## HISTORIC AND DESIGN REVIEW COMMISSION

**HDRC CASE NO:** 2020-442  
**ADDRESS:** 831 BURLESON ST  
**LEGAL DESCRIPTION:** NCB 1301 BLK 2 LOT 21 & 22  
**ZONING:** RM-5, H  
**CITY COUNCIL DIST.:** 2  
**DISTRICT:** Dignowity Hill Historic District  
**APPLICANT:** Dianet Lopez Daniel  
**OWNER:** DELAFIELD INVESTMENTS LLC  
**TYPE OF WORK:** Front yard fence  
**APPLICATION RECEIVED:** October 05, 2020  
**60-DAY REVIEW:** Not applicable due to City Council Emergency Orders  
**CASE MANAGER:** Huy Pham

1. install a 4-foot tall wood-framed cattle panel front yard fence with driveway and pedestrian gates
2. install a 6-foot tall rear wood privacy fence

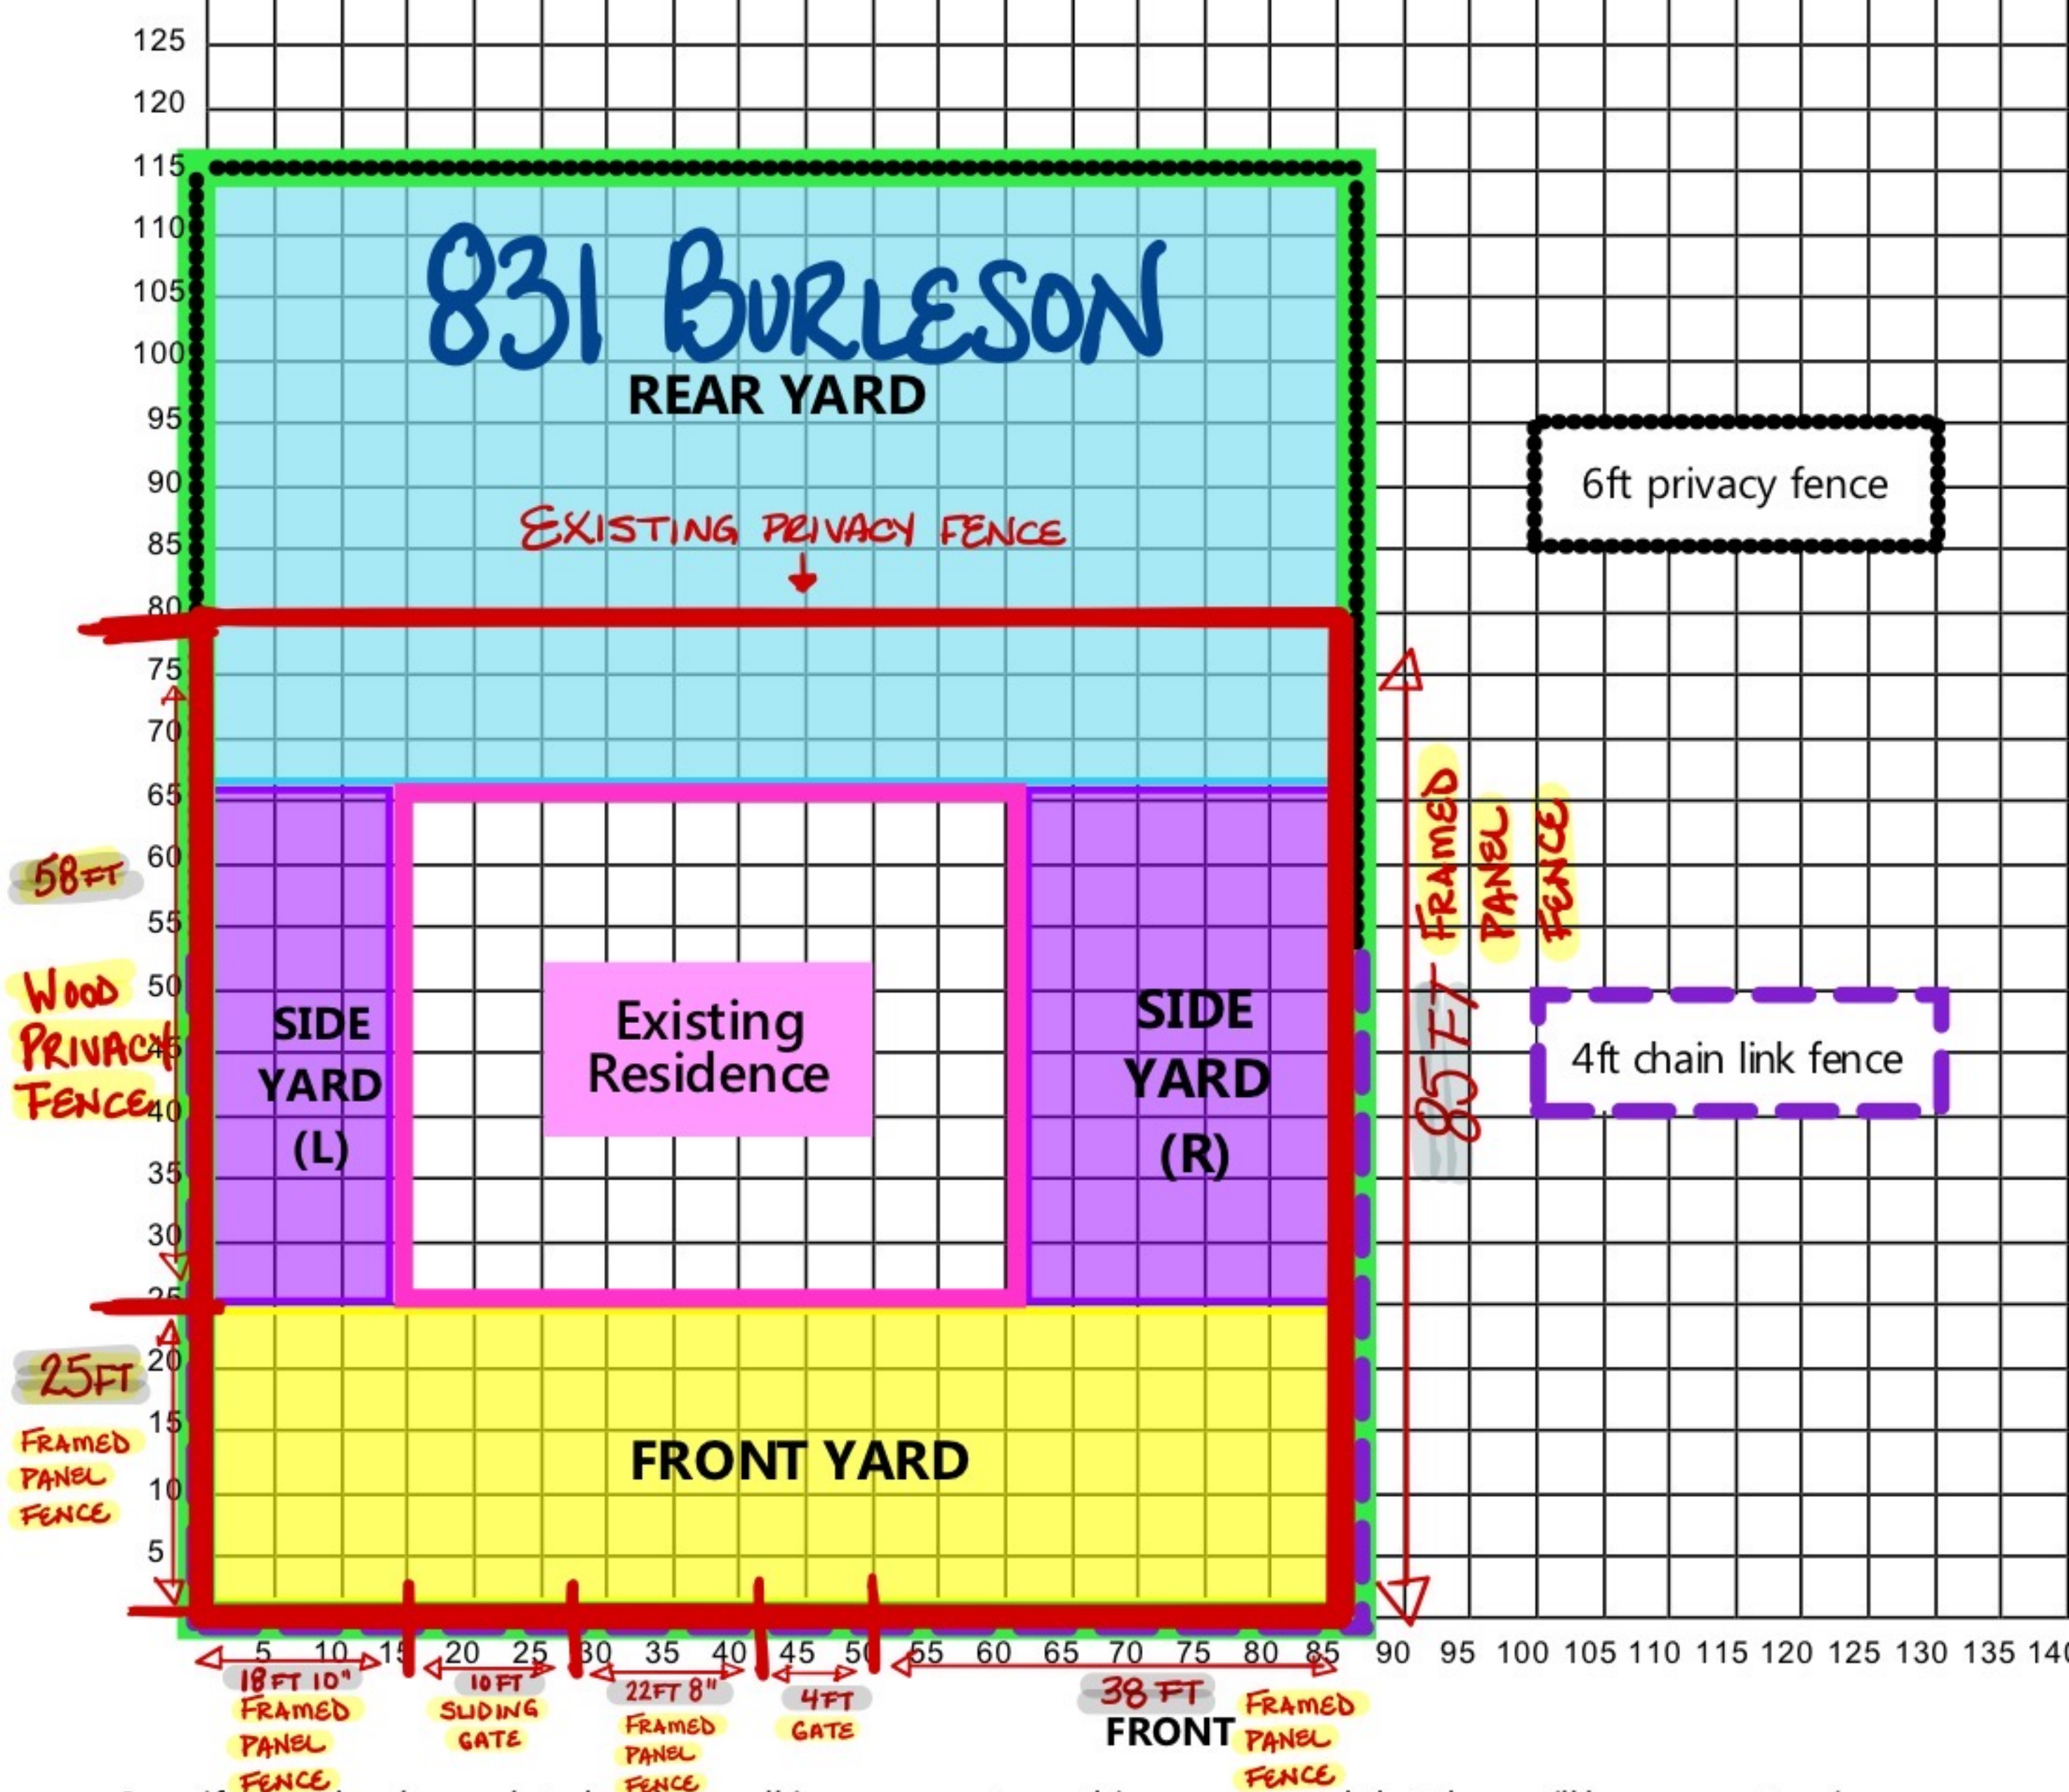
- c. FENCE LOCATION – The applicant has proposed to install the fence around the front and side property lines to meet the proposed rear wood privacy fence. Per the Guidelines for Site Elements 2.B.ii., applicants should

avoid installing a fence or wall in a location where one did not historically exist, particularly within the front yard; the appropriateness of a front yard fence or wall is dependent on conditions within a specific historic district; new front yard fences or walls should not be introduced within historic districts that have not historically had them. Staff finds that fences are found on Burleson on similar properties and within the Dignowity Hill Historic District.

- e. GATES – The applicant has proposed to install a front driveway gate matching in height and design as the proposed fence. Per the Fences Policy Guide, drafted January 2020, - Vehicle gates should be set behind the front facade plane of the house and not span across the front of the driveway. A front vehicle gate may be considered if the site features an atypical condition including: (a) a wraparound porch, (b) a narrow driveway less than 10 feet wide, and/or (c) front driveways abutting rear yards or commercial properties. Considering the width of the property and the corner configuration, staff finds the proposed driveway gate to be appropriate more than the typical recommendation to turn at the corner of the driveway instead of span across.

Staff recommends fence installation based on finding b through f with the stipulation the front yard fence feature a wood picket or wrought iron design instead of the proposed cattle panel.
